Access Compliance Report

Public Rights-of-Way

Intersection ID: 10039822	Main Street: TOM_SHORT_RD	Cross Street: N/A	Location: SW
ADA ID: A8FE22769833	Ramp Type: PerpDiag	Initial Pass/Fail: Fail	Overall Compliance: No
		Severity Score: 12.5

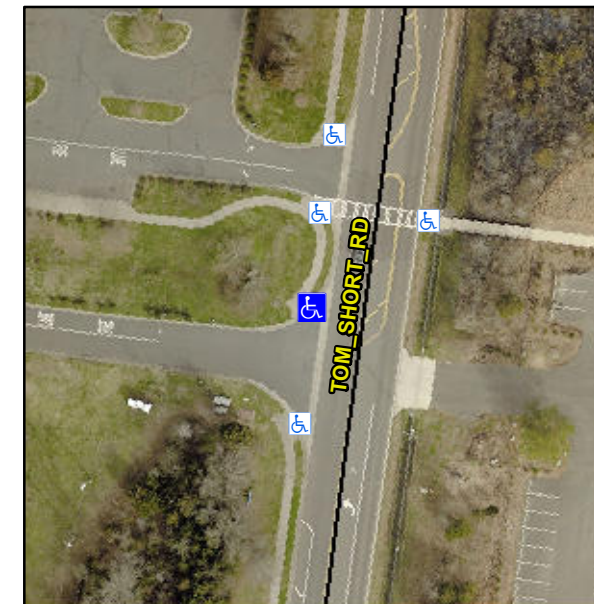
Compliance	Description	Data	Compliance	Description	Data
N/A	Ramp Length (in)	47.0	No	Ramp Slope (%)	9.1
Yes	Ramp Width (in)	57.0	Yes	Ramp XSlope (%)	0.2
N/A	Flare Type LT	N/A	N/A	Flare Type RT	N/A
N/A	Flare Slope LT (%)	N/A	N/A	Flare Slope RT (%)	N/A
N/A	Flare Traversable LT?	N/A	N/A	Flare Traversable RT?	N/A
N/A	Landing Length (in)	N/A	N/A	DWS Provided?	N/A
N/A	Landing Width (in)	N/A	N/A	DWS Contrast?	N/A
N/A	Landing Slope (%)	N/A	N/A	DWS Length (in)	N/A
N/A	Landing X Slope (%)	N/A	N/A	DWS Full Width?	N/A
N/A	Landing Curb? (Y/N)	N/A	N/A	DWS Offset (in)	N/A
N/A	Shared Landing?	N/A			
N/A	Gutter Ponding?	N/A	N/A	Gutter Slope (%)	N/A
N/A	Gutter Lip Ht (in)	N/A	N/A	Gutter X Slope (%)	N/A
N/A	Painted X Walk1?	No	N/A	Painted X Walk2?	No
	X Walk 1 Direction	To SW		X Walk 2 Direction	To SE
N/A	X Walk 1 Width (in)	N/A	N/A	X Walk 2 Width (in)	N/A
	X Walk 1 Slope (%)	1.0		X Walk 2 Slope (%)	0.3
	X Walk 1 X Slope (%)	0.0		X Walk 2 X Slope (%)	0.9

Possible Solutions:

Remove & Replace Curb Ramp With Two New Directional Ramps or Equivalent.
